NYN- 94035

Subject: Response to Request for Additional Information (TAC M86957 and TAC M86958)

RESPONSE TO REQUEST FOR ADDITIONAL INFORMATION
REVIEW OF YAEC-1849P

RESPONSE TO REQUEST FOR ADDITIONAL INFORMATION
REVIEW OF YAEC-1856P

FIGURE 3.1

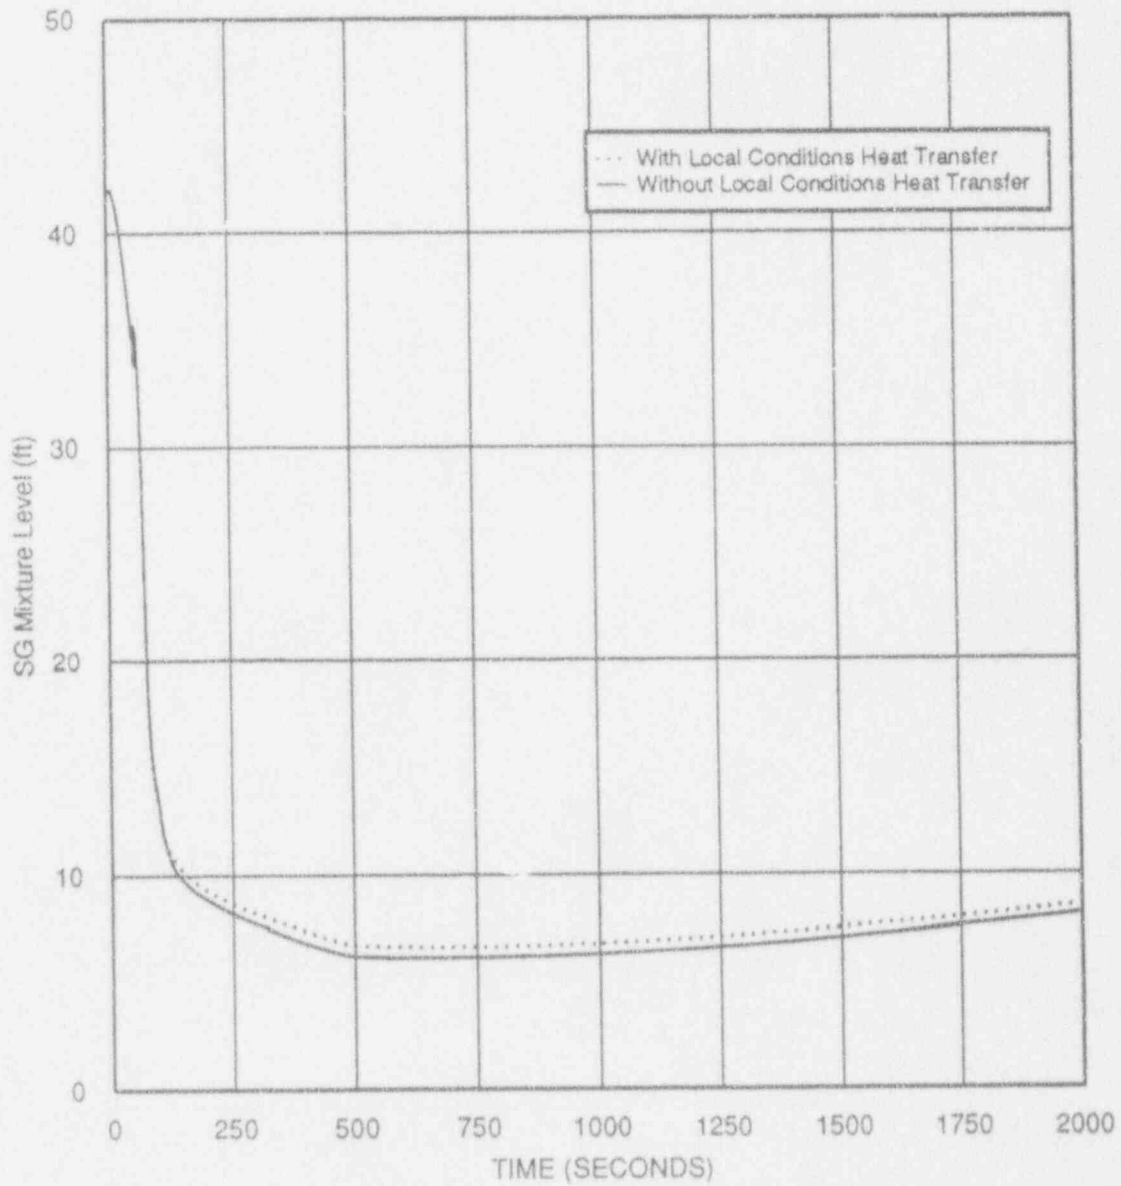
6. *Explain and justify the upper head circulation path modeling and demonstrate that predicted flows are realistic and/or conservative on a transient-by-transient.*

The upper head bypass flow in the RETRAN model is conservatively low based on NSSS vendor data. The RETRAN upper head volume is, therefore, assumed to be relatively stagnant reducing its availability to attenuate the rate of heatup and cooldown during Chapter 15 type events. For Seabrook Station the Reactor Vessel (RV) internals have flow passages which by design allow cold coolant from the inlet nozzles to bypass the core and pass directly to the upper head. Therefore, initial coolant temperature in the upper head is equal to T_{cold} . The upper head modeling has an insignificant impact on Chapter 15 transients except for some primary side depressurization events, e.g., MSLB. Refer to Appendix A of these RAI responses for additional discussion.

YR RETRAN SIMULATION
LOSS OF Z-126 HIGH LINE EVENT
(LOSS OF OFF-SITE POWER)

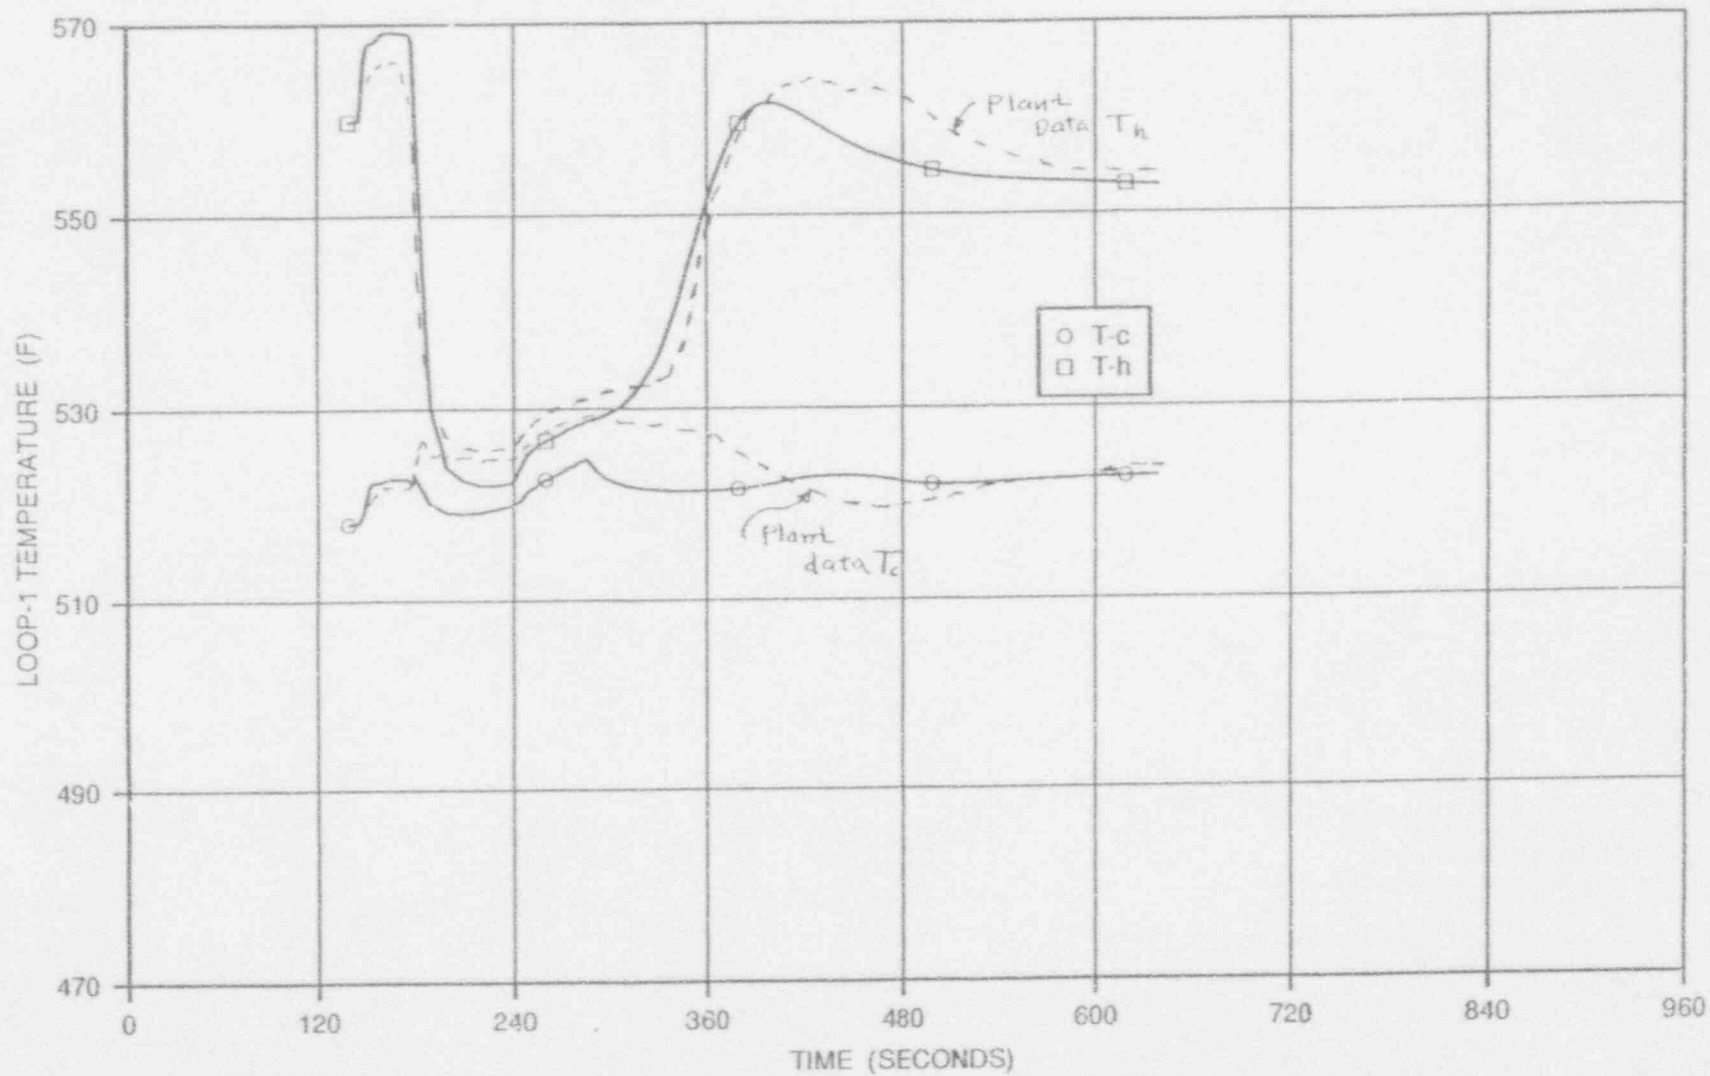
11. *Explain why RTN initial conditions were not matched with the data for natural circulation test for Seabrook. Justify the statement that the difference in hot leg temperatures between 100 and 300 seconds while the cold leg temperature were matched with an offset in the initial conditions was caused by the modeling of steam dump control system. Discuss the source(s) of the hot leg temperatures. Does YAEC have similar analysis for other plants? In order to assure that the steam dump control system modeling is the source of mismatch (as YAEC postulates) in some benchmark analyses, provide the description of the simple steam dump model.*

Our primary focus and concern in the benchmark of the Seabrook natural circulation test was the final conditions reached following the tripping of reactor coolant pumps (RCPs). The matching of final conditions is a strong indication that the hydraulic modeling of the plant is an accurate representation of specific plant conditions for transients where power to the RCPs is lost. The model used in the test benchmark was initialized based on data (primary to secondary) at power. The test were run at zero power. The difference of approximately 2 degrees in initial average temperature between the RETRAN simulation and the data is attributed to this difference.

Your observation that the difference in hot leg response could not be attributed to the steam dump controller because the cold leg response agreed is correct. YAEC was misled in our postulation because of our focus on the final conditions and because of our understanding that the plant had some difficulty with the steam dump controller during the test. After evaluating the differences in hot leg responses further, and looking at similar analysis for Yankee Rowe, we have concluded that the differences are attributed to differences in RTD response times and the specific location of the hot leg RTD used in the Seabrook test.

The attached Figure shows the results of a similar analysis performed for Yankee Rowe. This analysis was of an actual event where one of two offsite power lines were lost and the plant was manually tripped by the operators. The operators also subsequently tripped the remaining RCPs placing the plant in natural circulation. The hot and cold leg responses, as shown in the attached Figure, are in good agreement with RETRAN predictions. The RTDs used to measure the responses at Yankee Rowe are mounted in thermo-wells in the loops and have relatively fast response times. At Seabrook the hot and cold leg RTDs consist of both narrow range and wide range. The narrow range RTDs, which feed into the reactor protection system, have a relatively fast response time similar to those at Yankee Rowe. The narrow range RTDs, at the time of the natural circulation test, were located in the loop bypass manifold and were unreliable during natural circulation conditions. The temperature measurements for the hot and cold leg responses for the natural circulation test were thus taken from the wide range channels. The wide range RTDs are located in the loops as opposed to the loop bypass manifold. Although the response times for the wide range channels have not been measured they are known to be slower than the response time of the narrow range channels (when the narrow range RTDs were located in the loop bypass manifold the response time was about 6 seconds with the RCPs operating). Under natural circulation conditions it is plausible for the wide range RTDs to have a response time on the order of 60 seconds. In addition, the location of the hot leg wide range RTD is closer to the steam generator than assumed in the RETRAN simulation accounting for part of the difference noted. This contributed approximately 40 seconds to the delay in the hot leg

temperature response. Therefore, the difference noted in hot leg response in Figure 4.1.4 of YAEC-1856P is attributed in part to the slow response time of the wide range RTDs and in part to the assumed location of the hot leg RTD in the RETRAN simulation.

GEMINI-II DECAY HEAT FUNCTION

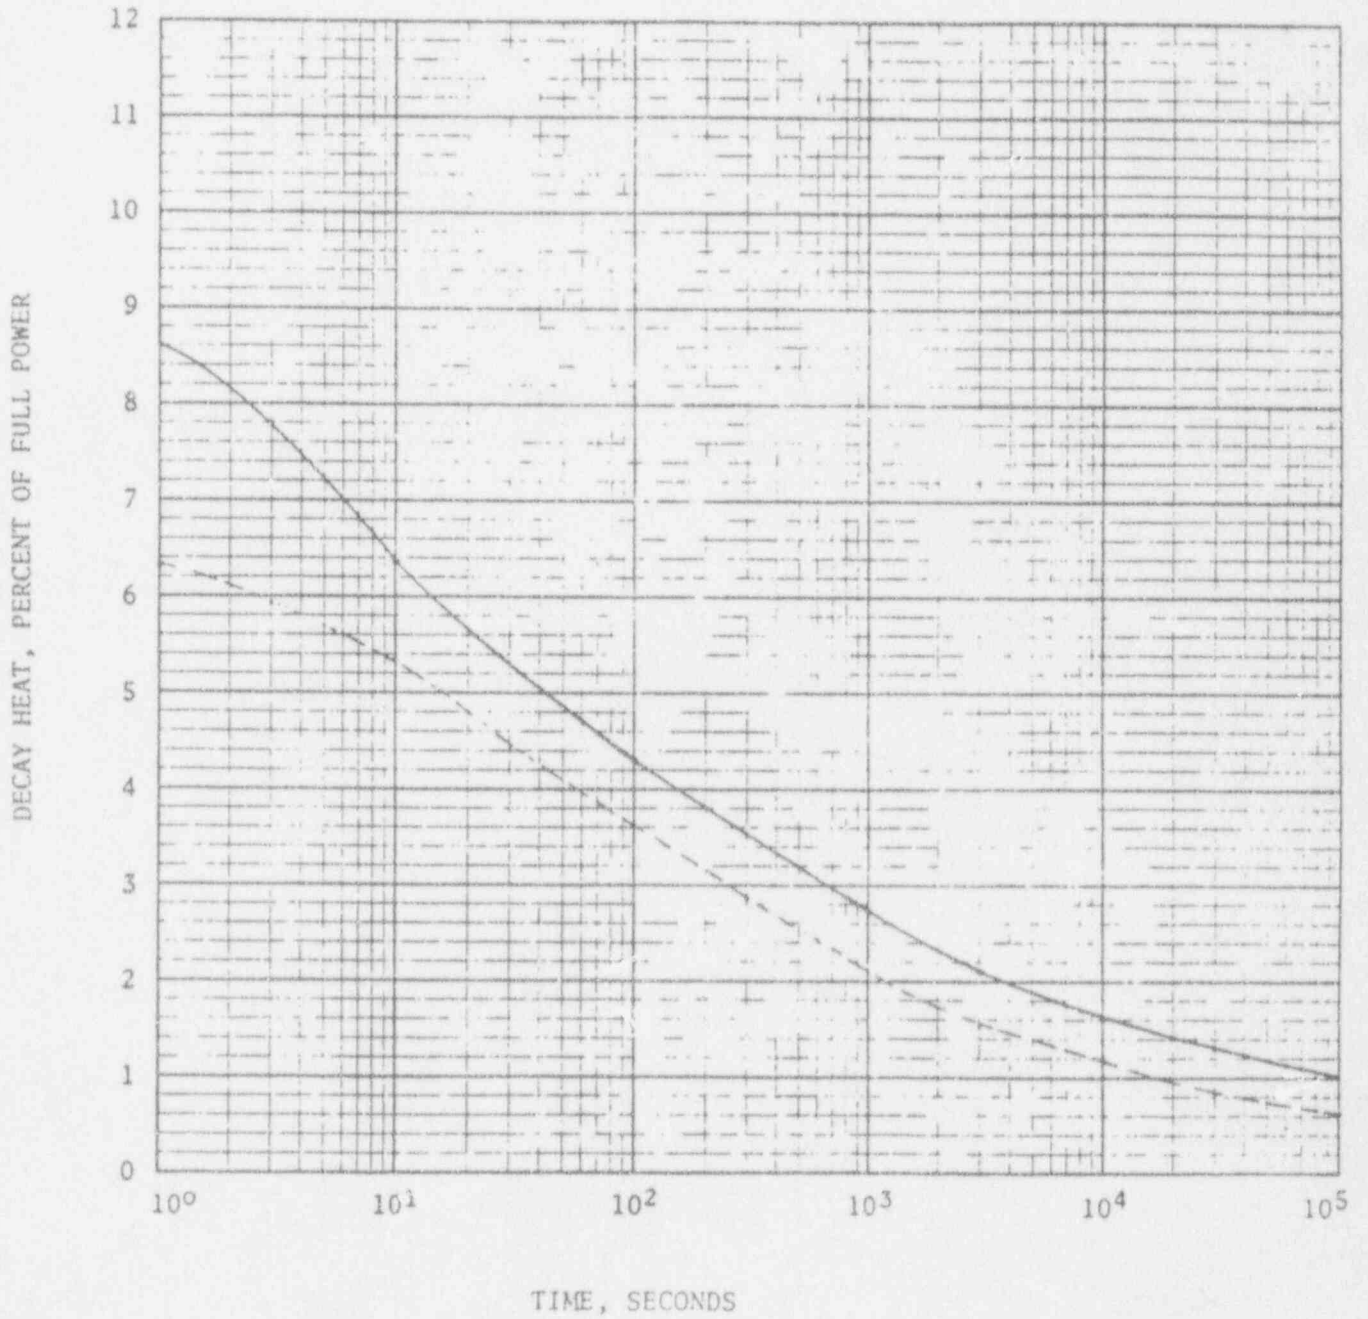
13. *Provide a loss of load analysis for Maine Yankee. YAEC demonstrated that for Yankee Rowe, GEMINI predicted higher pressure than RETRAN at slightly earlier time. Explain the reasons for the divergent results after the pressure peaked.*

The intent of the Yankee Rowe loss of load comparison presented in Figure 4.2.2 of YAEC-1856P was to provide an indirect comparison of YAEC's pressurizer modeling technique (treatment of interfacial heat transfer etc.) for overpressure transients against data. Figure 4.2.1 of YAEC 1856P presented results of a comparison of GEMINI predictions to data from Shippingport for a rapid insurge transient. GEMINI is YAEC's currently approved transient analysis model for these types of events. The comparison shows that the GEMINI prediction is conservative relative to the data. Comparison of the RETRAN response to GEMINI provides an indirect comparison of the RETRAN response to data. Peak pressures agree well but diverge following reactor trip. The divergence is attributed to differences in the post-trip

heat input to the Reactor Coolant System (RCS) from the following sources:

1. Decay Heat - The decay heat in GEMINI is greater than that in RETRAN. RETRAN uses the 1973 ANS standard. The attached figure compares the GEMINI decay heat model to the 1971 ANS standard.
2. Delayed Fissions - The heat from delayed fissions following the trip is greater in GEMINI than in RETRAN due to the different delayed neutron fractions used.
3. Stored Energy - The initial stored energy in the fuel used in GEMINI is conservatively larger than that in the RETRAN simulation.
